Re: Augmented SVE Trench Completion Report for Attachment Z-1 Remedy  
Consent Decree, Civil Action No. IP 83-1419-C-M/S  
Envirochem Site, Zionsville, Indiana

**AUGMENTED SVE TRENCH  
COMPLETION REPORT  
FOR  
ATTACHMENT Z-1 REMEDY**

**ENVIRO-CHEM SUPERFUND SITE  
ATTACHMENT Z-1 REMEDY  
985 SOUTH U.S. HIGHWAY 421  
ZIONSVILLE, INDIANA**

April 30, 2009

| DATE<br>04/29/09    | CONTRACT NUMBER:<br>21-6585K | FIGURE<br>C-9 |

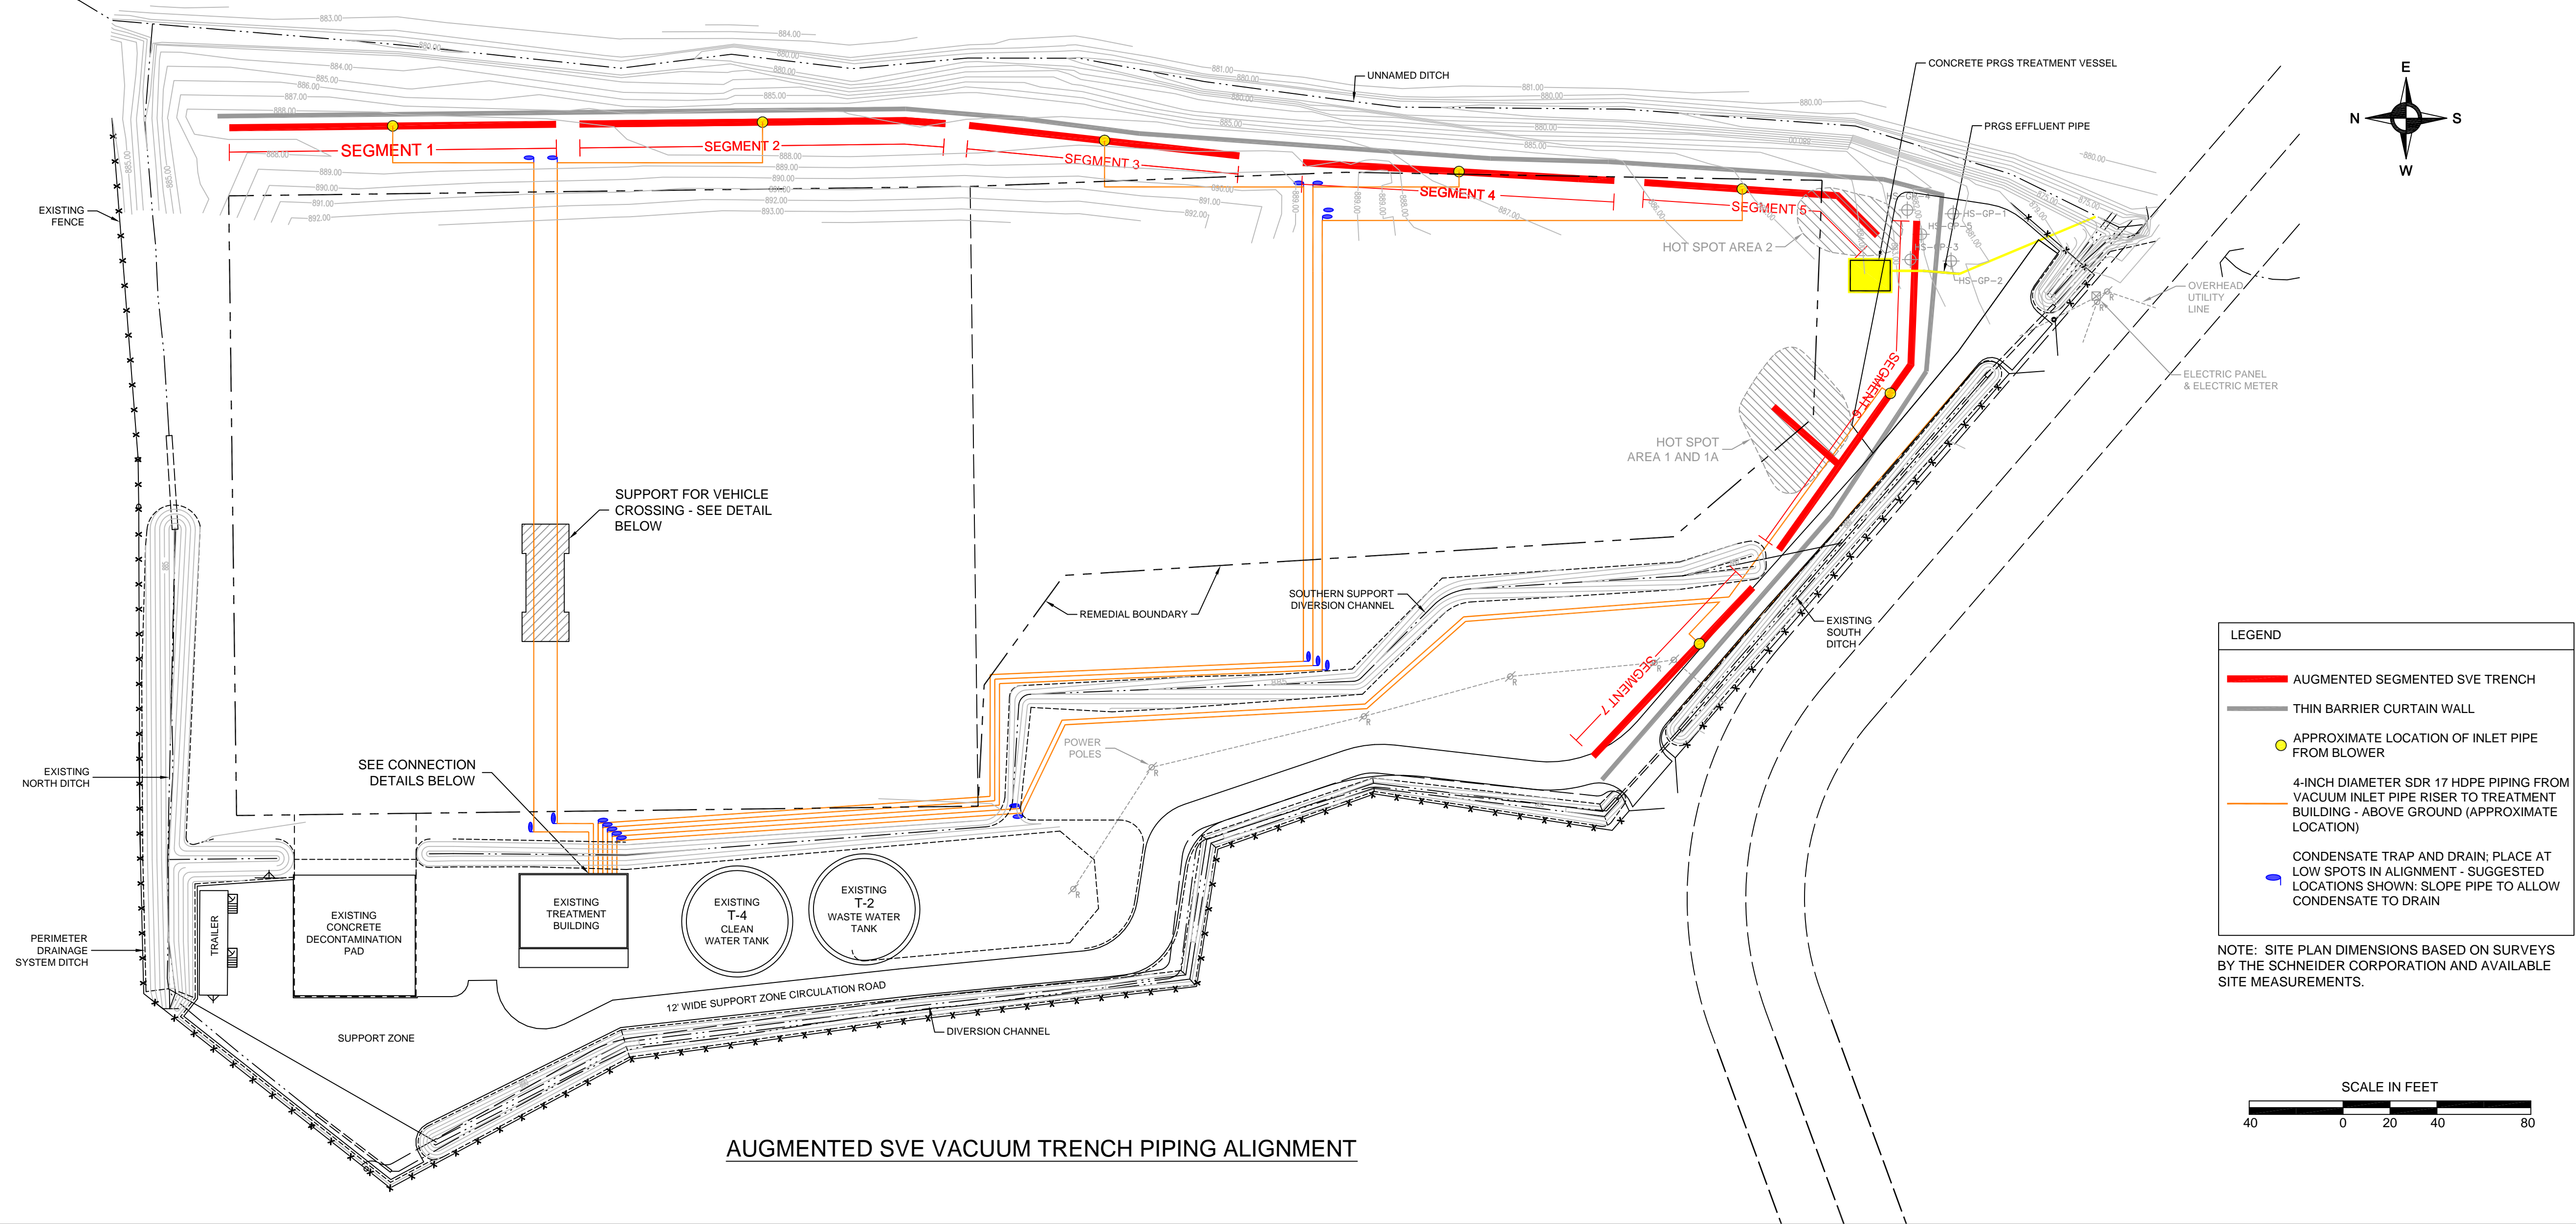
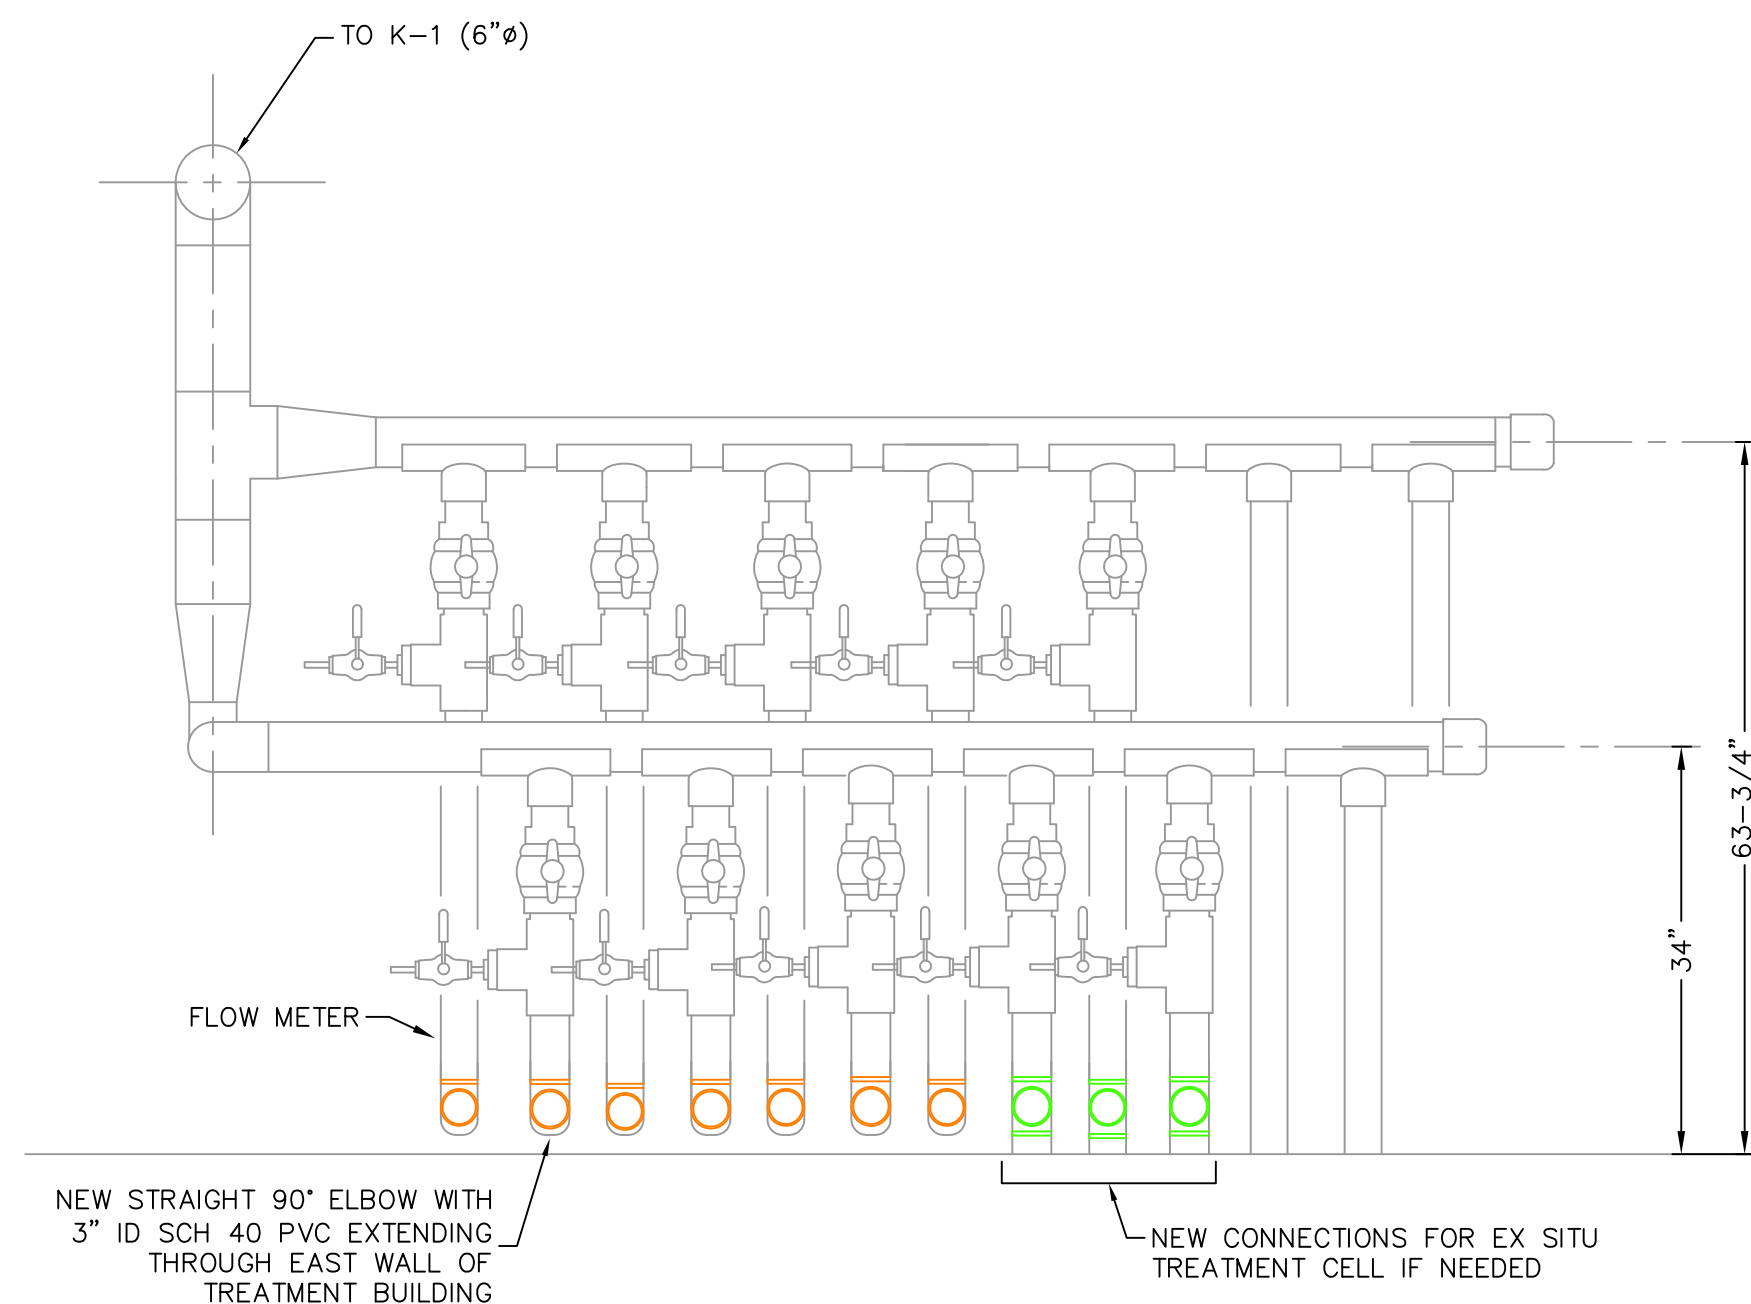
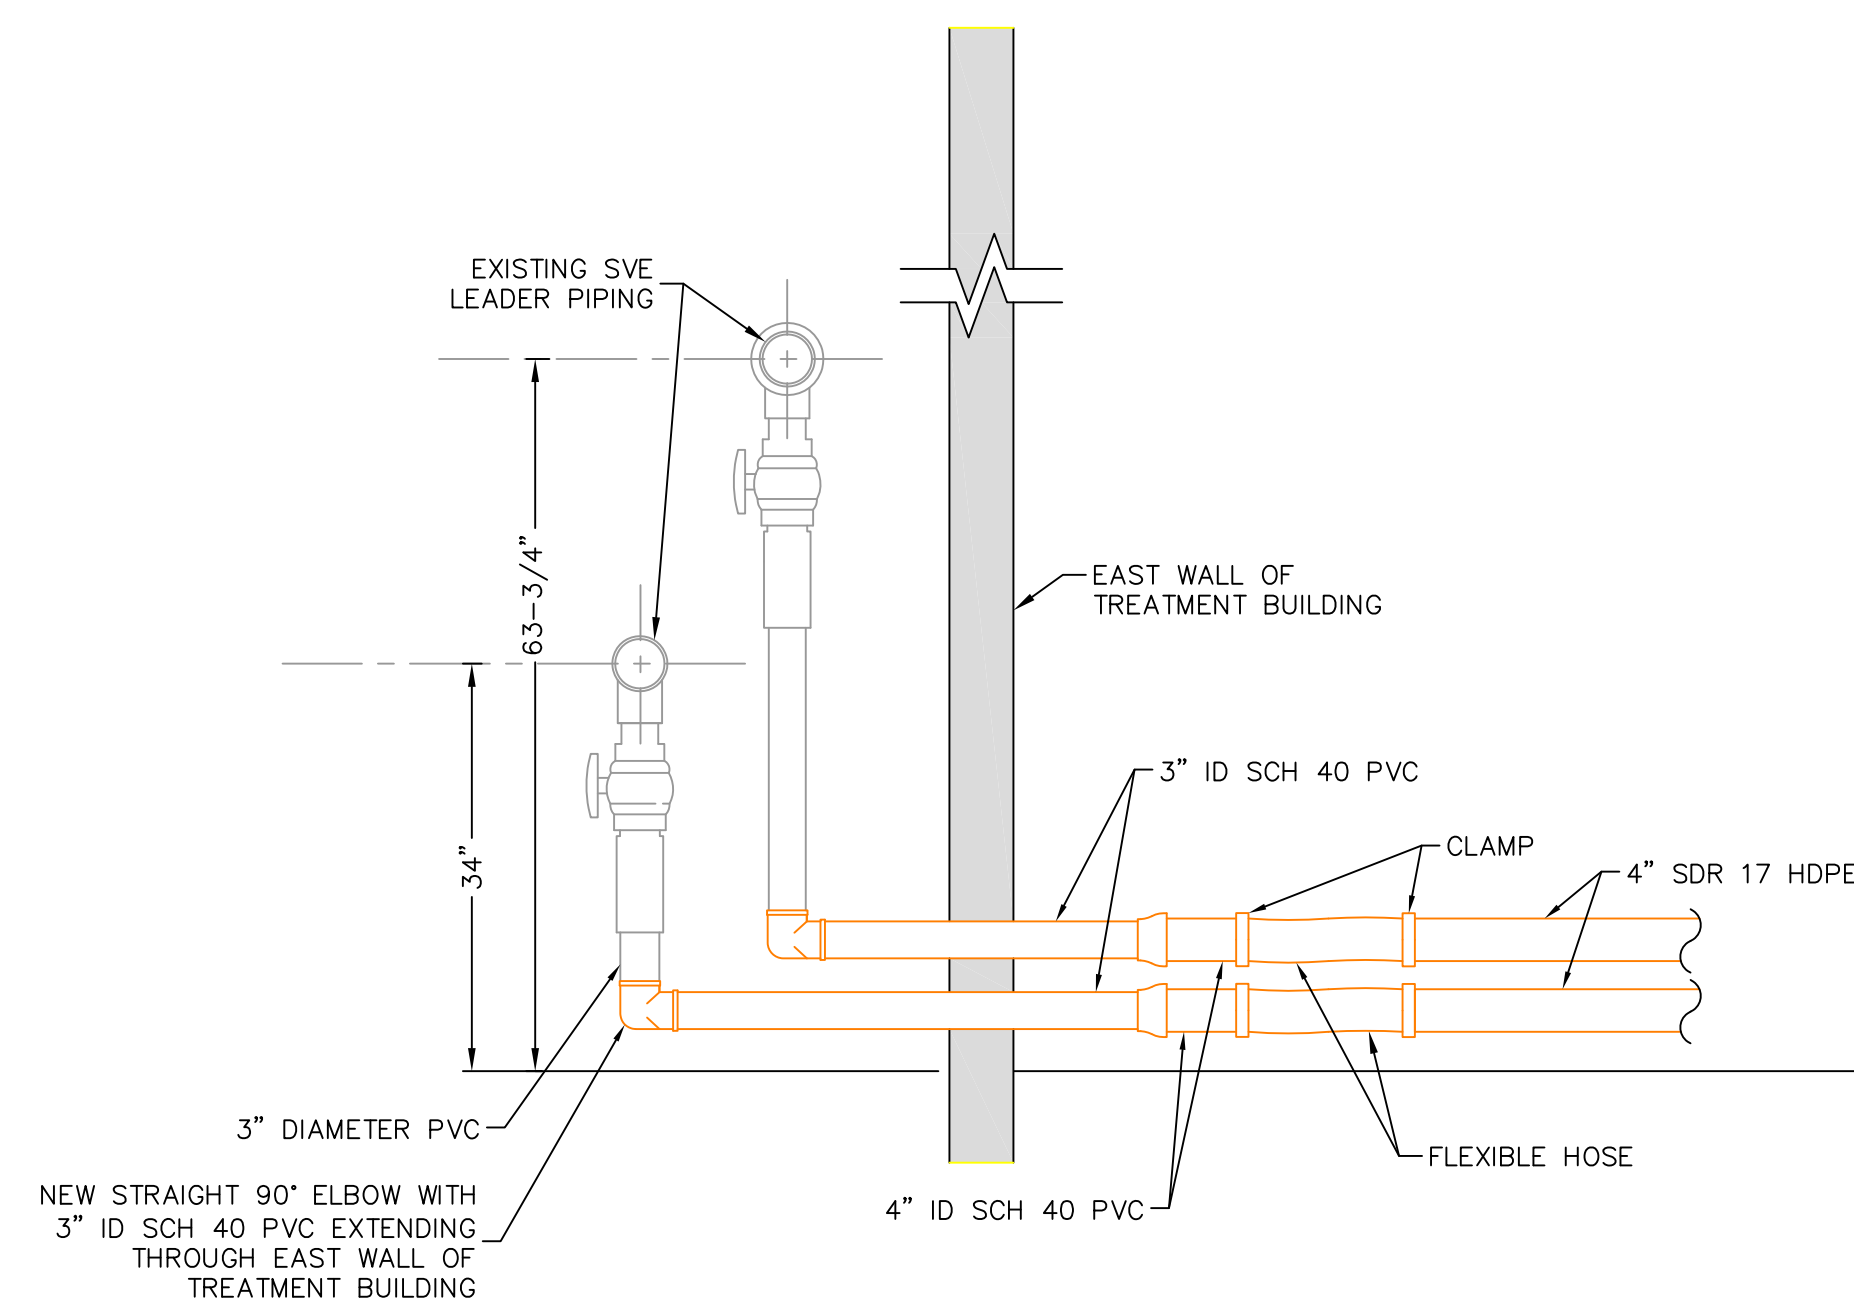
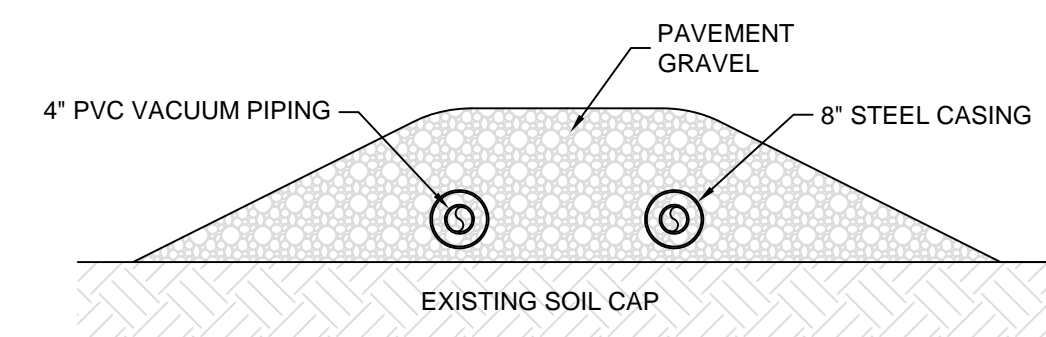
- Comment 5: See Section 1.2.5.8, page 9.
- Comment 6: Section numbering after Section 1.2 corrected as noted.
- Comment 7: See Section 1.3.9, page 11.
- Comment 8: See revised Figure C-9.
